HILCORP ENERGY COMPANY
SAN JUAN 31-6 UNIT 6
P&A NOI

CONDITIONS OF APPROVAL

Notice of Intent - Plug and Abandonment

Operator: Hilcorp Energy Company
Lease: NMSF079000
Agreement: NMNM78421A
Well(s): San Juan 31-6 Unit 6, API # 30-039-07914
Location: NWSW Sec 1 T30N R7W (Rio Arriba County, NM)
Sundry Notice ID#: 2867095

SAN JUAN 31-6 UNIT 6 - PROPOSED WELLBORE SCHEMATIC

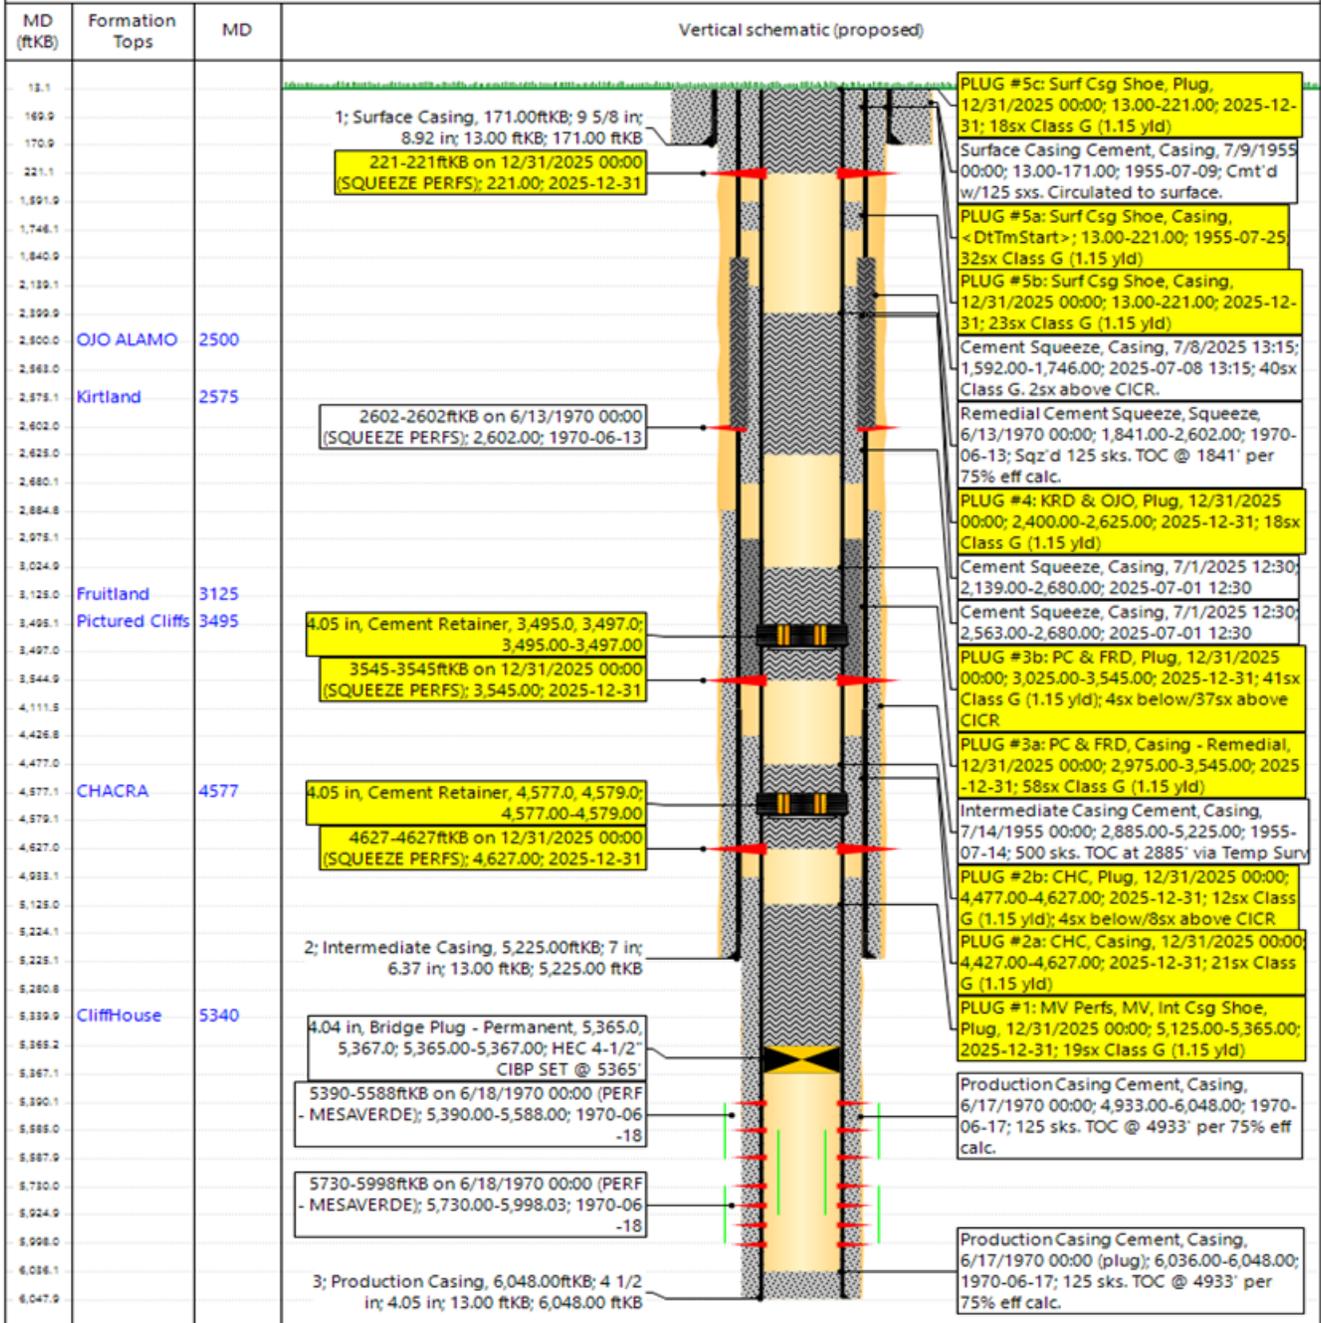
3. **The following modifications to your plugging program are made:**
 - a. Adjust Plug 2 (Chacra) BOC to 4,637' to account for BLM Geologist's Chacra formation top pick @ 4,587'. Perforate squeeze holes @ 4,637' and set CICR @ 4,587'.

- b. Adjust Plug 3 (Picture Cliffs/Fruitland) BOC to 3,440' to account for BLM Geologist's Picture Cliffs formation top pick @ 3,390' and TOC to 2,843' to account for BLM Geologist's Fruitland formation top pick @ 2,943'. Perforate squeeze holes @ 3,440' and set CICR @ 3,390'.

- c. Adjust Plug 4 (Kirtland/Ojo) BOC to 2,650' to account for BLM Geologist's Kirtland formation top pick @ 2,600' and TOC to 2,295' to account for BLM Geologist's Ojo Alamo formation top pick @ 2,395'.

- d. Add plug to cover BLM Geologist's Nacimiento pick @ 1,110'. Plug should at a minimum cover 1,010' – 1,160' inside and outside.
4. Additional changes to procedure, before or during plugging, should be sent through email to Kenneth Rennick (krennick@blm.gov) and Matthew Kade (mkade@blm.gov) for approval. Verbal approvals may be given and must be followed up with an email documenting the requested changes.
